ATTACHMENT TO LICENSE AMENDMENTS NO. 6 AND NO. 5
CHANGE NO. 18 TO THE TECHNICAL SPECIFICATIONS
FACILITY OPERATING LICENSE NO. DPR- 31 AND NO. DPR-41
FLORIDA POWER AND LIGHT COMPANY
TURKEY POINT NUCLEAR GENERATING UNITS 3 AND 4
DOCKETS NOS. 50-250 AND 50-251

SAFETY EVALUATION BY THE DIVISION OF REACTOR LICENSING

SUPPORTING AMENDMENT NO. 6 TO LICENSE NO. DPR-31, AND

TURKEY POINT NUCLEAR GENERATING UNITS 3 AND 4

FIGURE 3.2-1

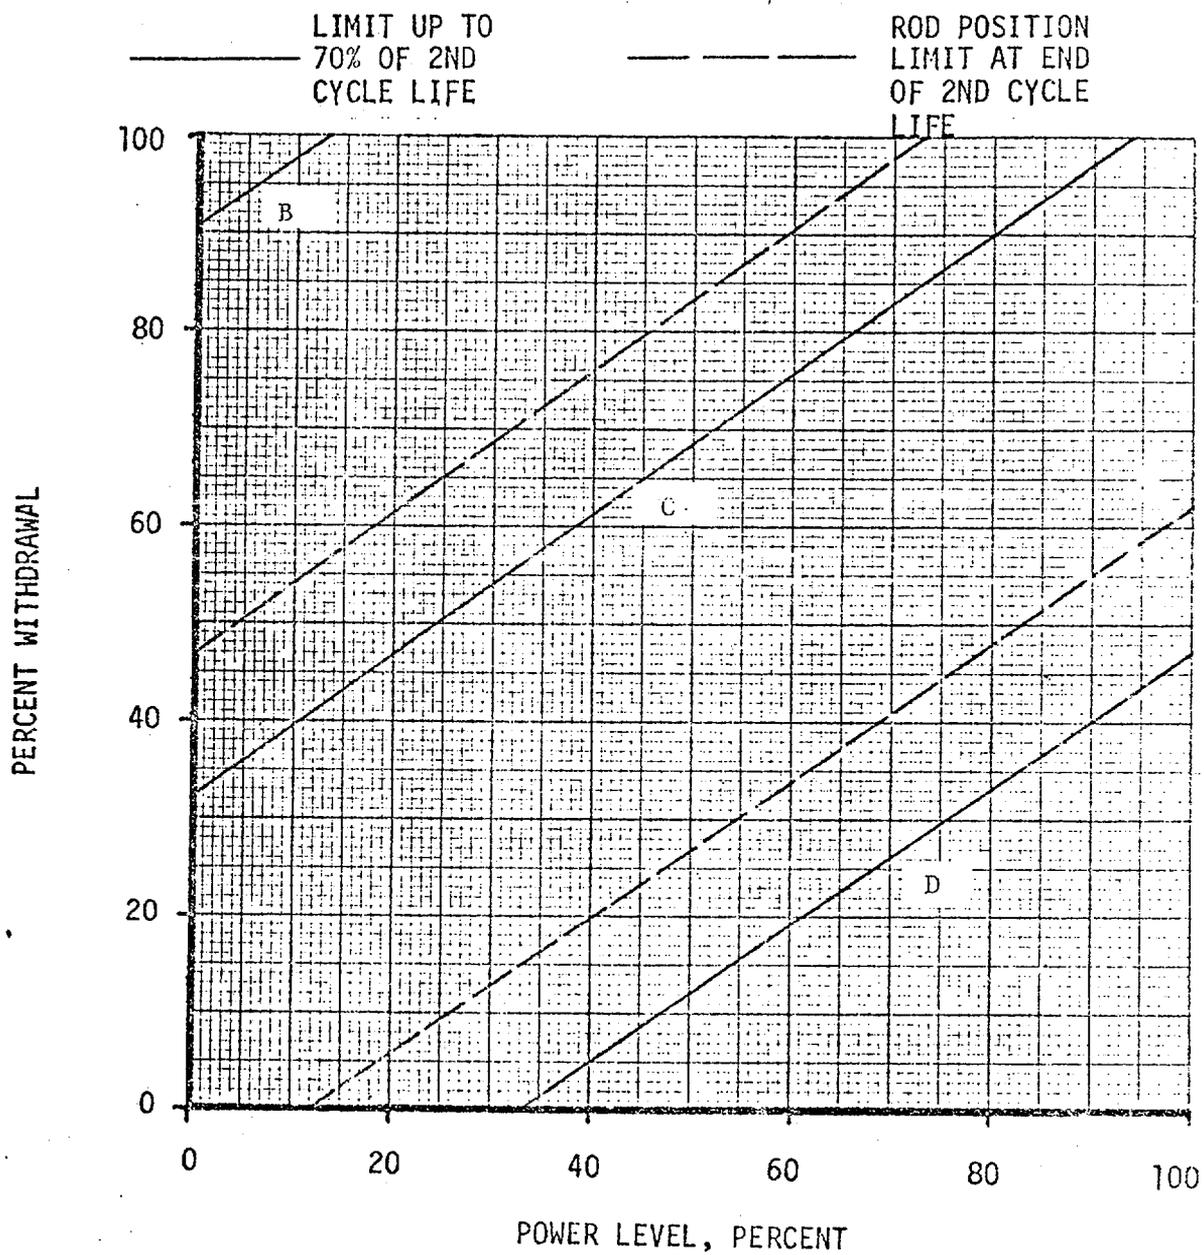
Revise Appendix A as follows: Replace pages 1-6, 3.2-1, Figure 3.2-1, and B 3.2-1 with the attached pages. Insert new Figure 3.2-1(a).

- c. After 70% of the second and subsequent cycles as defined by burnup, the limits shall be adjusted as a linear function of burnup toward the end-of-core life as shown by the dotted lines on Figure 3.2-1.

- d. The end-of-core life limit shown on Figure 3.2-1 may be revised on the basis of physics calculations and physics data obtained during startup and subsequent operation.

CONTROL GROUP INSERTION LIMITS
 FOR UNITS 3 AND 4 THREE LOOP
 OPERATION AND UNIT 4 TWO
 LOOP OPERATION

FIGURE 3.2-1(a)

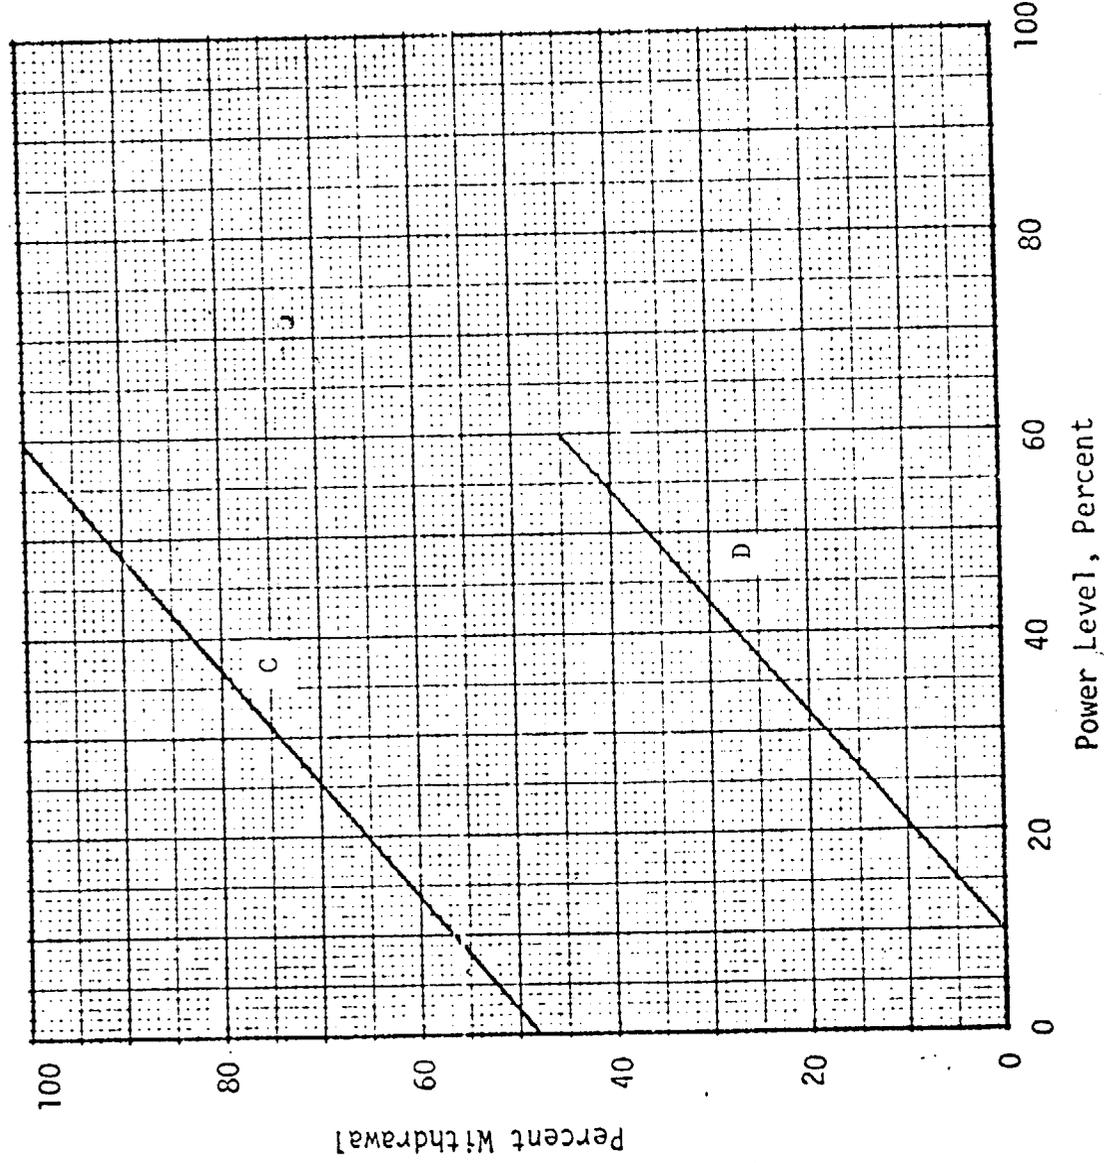
- a. Whenever the reactor is critical, except for physics tests and control rod exercises, the shutdown control rods shall be fully withdrawn.
- b. Whenever the reactor is critical, except for physics tests and control rod exercises, the control group rods shall be no further inserted than the limits shown by the solid lines on Figure 3.2-1 for three loop operation on Units 3 and 4 and two loop operation on Unit 4. For two loop operation on Unit 3 the control group rod insertion limits are shown on Figure 3.2-1(a).

FPL has analyzed the control rod insertion limits for both three loop and two loop operation and has proposed control rod insertion limits for two loop operation which are more conservative than the presently specified end-of-life (EOL) limits. FPL has not proposed a change to the control rod insertion limits for three loop operation as their analysis shows the specified three loop insertion limits are more conservative than necessary. We have reviewed FPL's request and since we find that the use of the proposed presently specified three loop control rod insertion limits and the proposed two loop control rod insertion limits will not effect previously performed applicable safety analyses, we approve of the proposed insertion limits. Use of the more conservative proposed control rod insertion limits will increase the minimum available shutdown margin, maintain an acceptable core power distribution and decrease the consequences of a control rod ejection accident.

CONTROL GROUP INSERTION LIMITS
FOR UNIT 3 CYCLE 2
TWO LOOP OPERATION
